## ADDENDUM NO. 1

January 22, 2026

907 CAROLINE STREET  
KEY WEST, FLORIDA

**A5**

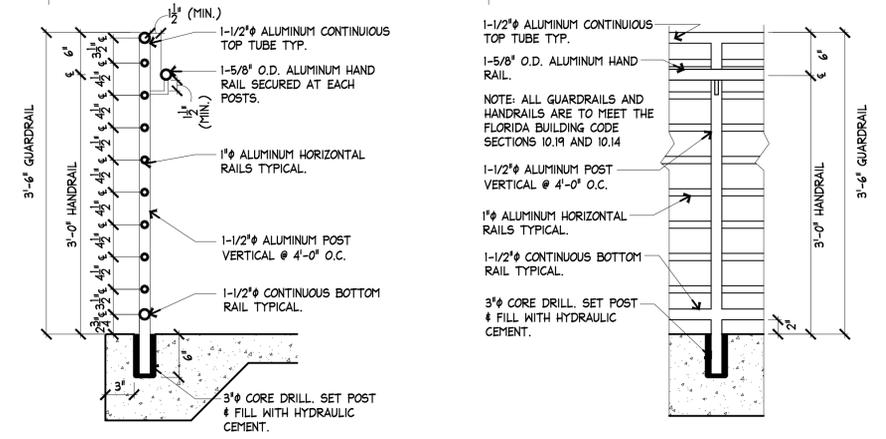
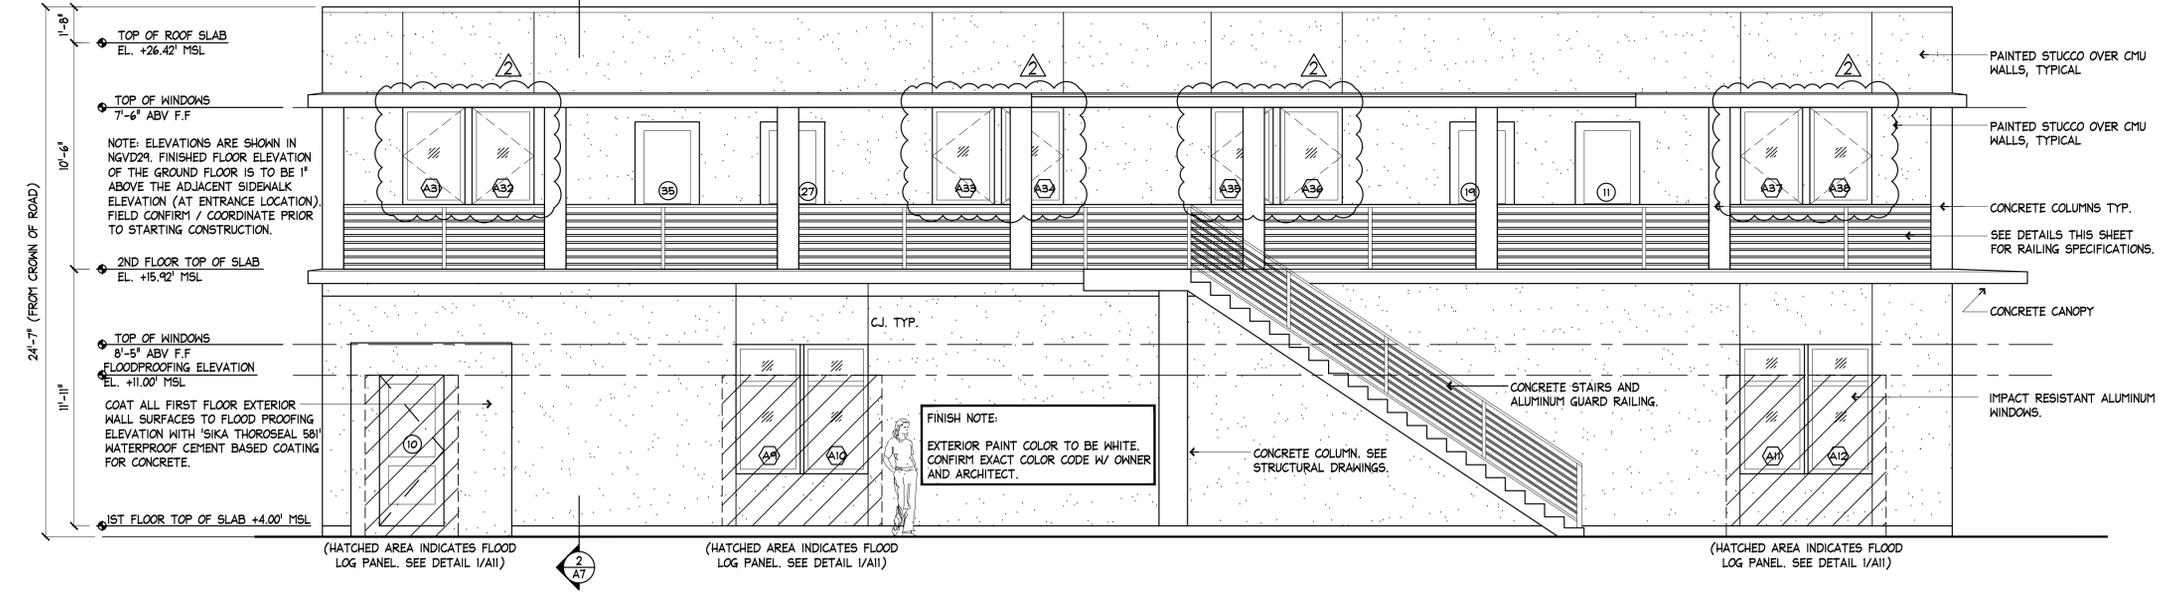
**Question:** Please provide opening directions of the casement windows A17 through A19, and A28 through A30 a. A22 through A25 and A31 through A38 are assumed to open opposite of each other.

**Response:** **See attached revised sheets indicating window opening directions.**

11/08/2024  
 BUILDING HEIGHT FROM  
 CROWN OF ROAD.  
 01/22/2026  
 INDICATING WINDOW SWING

E4

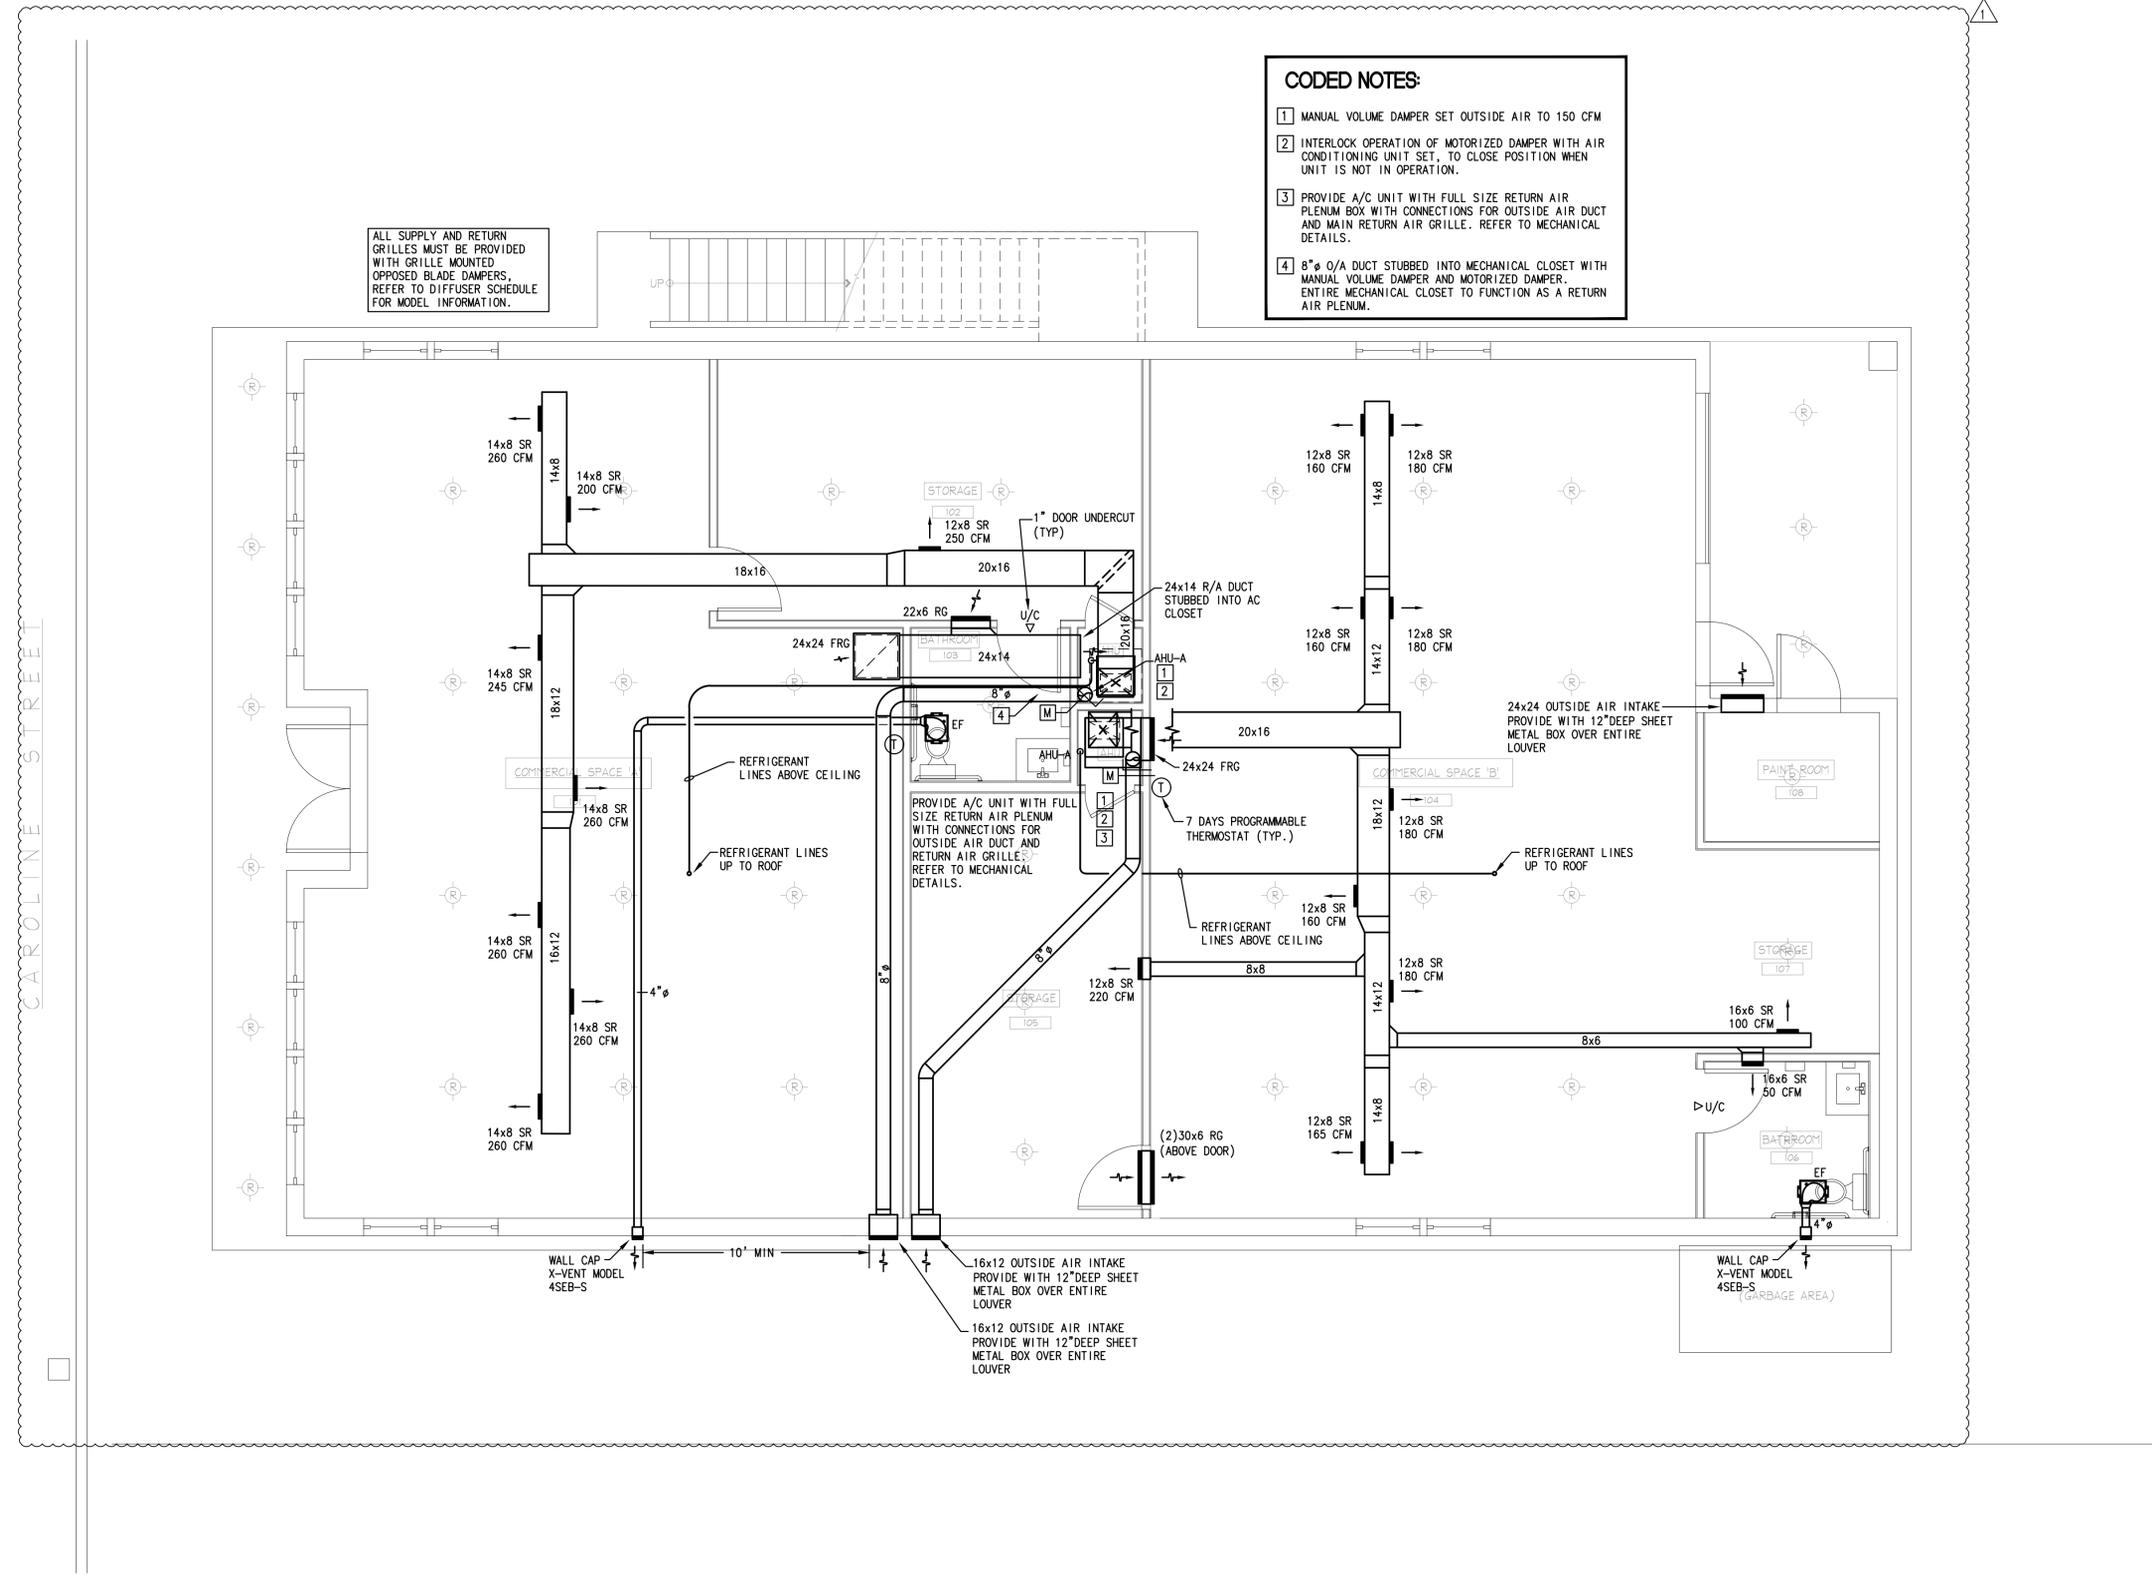
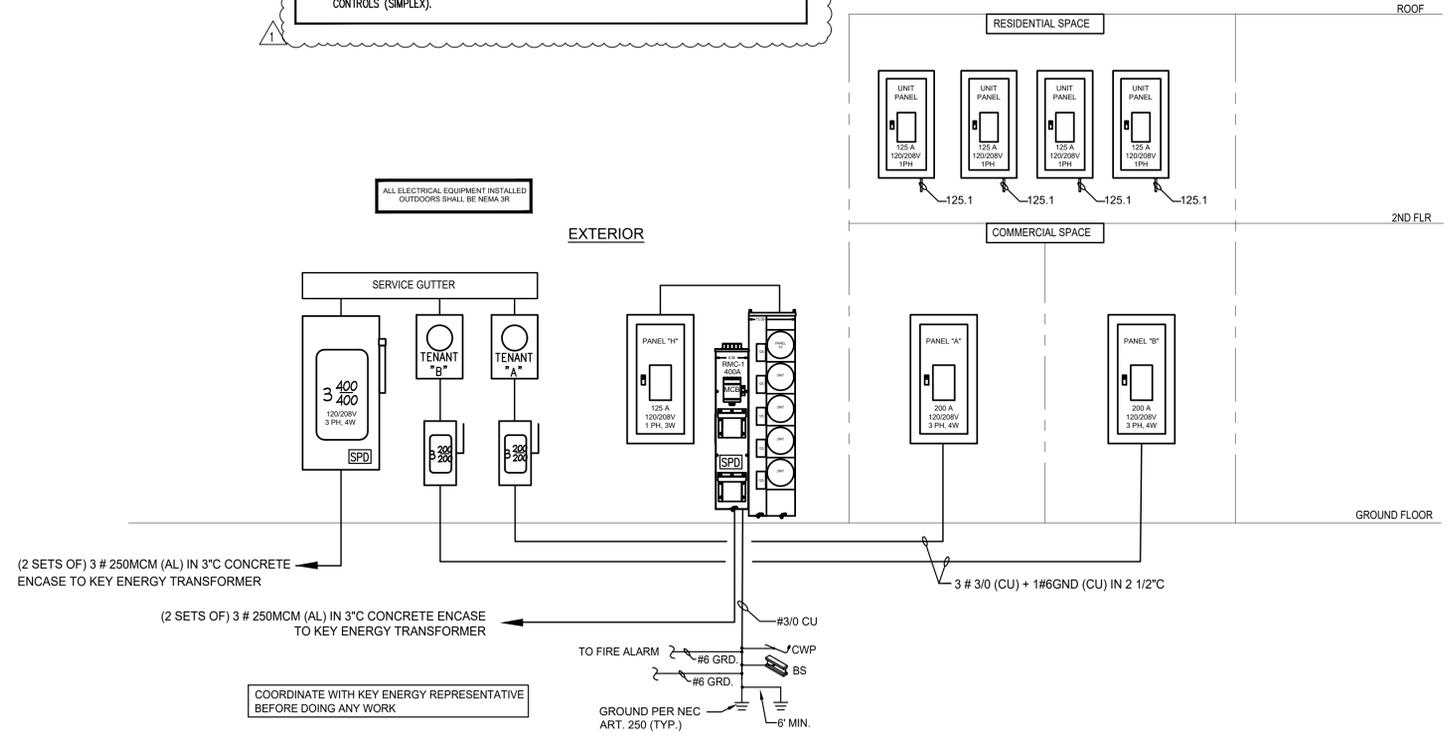
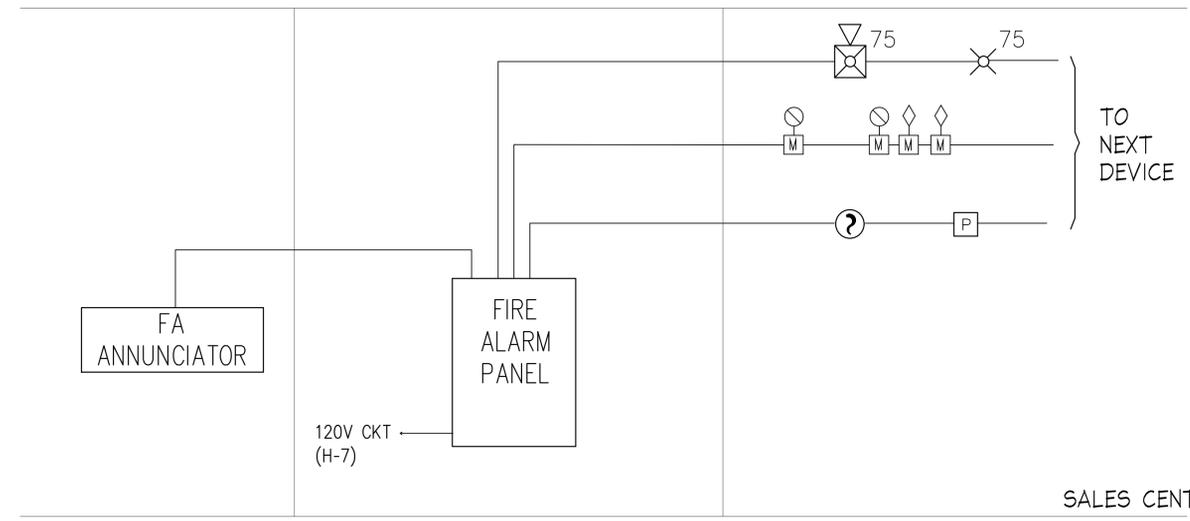
**Question:** Please provide Fire Alarm specifications.

**Response:** **See revised sheet E4.**

1 FIRST FLOOR MECHANICAL PLAN  
M1 SCALE: 1/4"=1'-0"

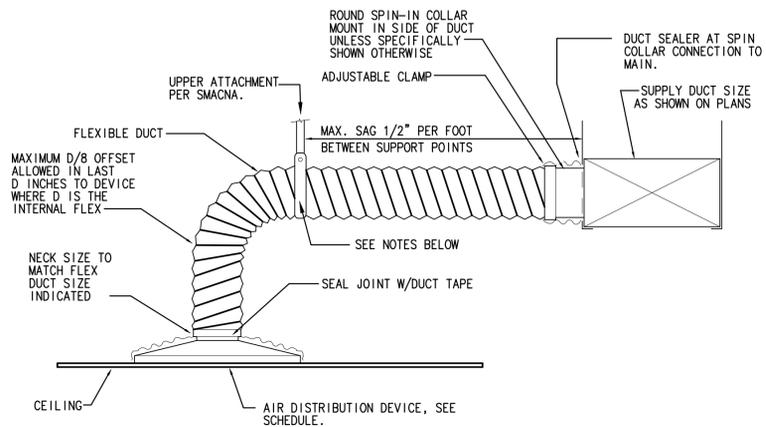
**Question:** The mechanical drawings do not indicate any supply or return ductwork serving the first-floor space. Please clarify the intended scope for the mechanical installation in this area. Specifically, should the mechanical equipment be provided with a basic supply plenum, or is the unit intended to be installed without ductwork and left capped/ready for future use? Please advise on the required configuration to ensure compliance with the design intent and project specifications.

**Response:** **See attached revised sheets M1 and M5 for ductwork layout.**

- 1 MANUAL VOLUME DAMPER SET OUTSIDE AIR TO 150 CFM
- 2 INTERLOCK OPERATION OF MOTORIZED DAMPER WITH AIR CONDITIONING UNIT SET, TO CLOSE POSITION WHEN UNIT IS NOT IN OPERATION.
- 3 PROVIDE A/C UNIT WITH FULL SIZE RETURN AIR PLENUM BOX WITH CONNECTIONS FOR OUTSIDE AIR DUCT AND MAIN RETURN AIR GRILLE. REFER TO MECHANICAL DETAILS.
- 4 8" Ø O/A DUCT STUBBED INTO MECHANICAL CLOSET WITH MANUAL VOLUME DAMPER AND MOTORIZED DAMPER. ENTIRE MECHANICAL CLOSET TO FUNCTION AS A RETURN AIR PLENUM.
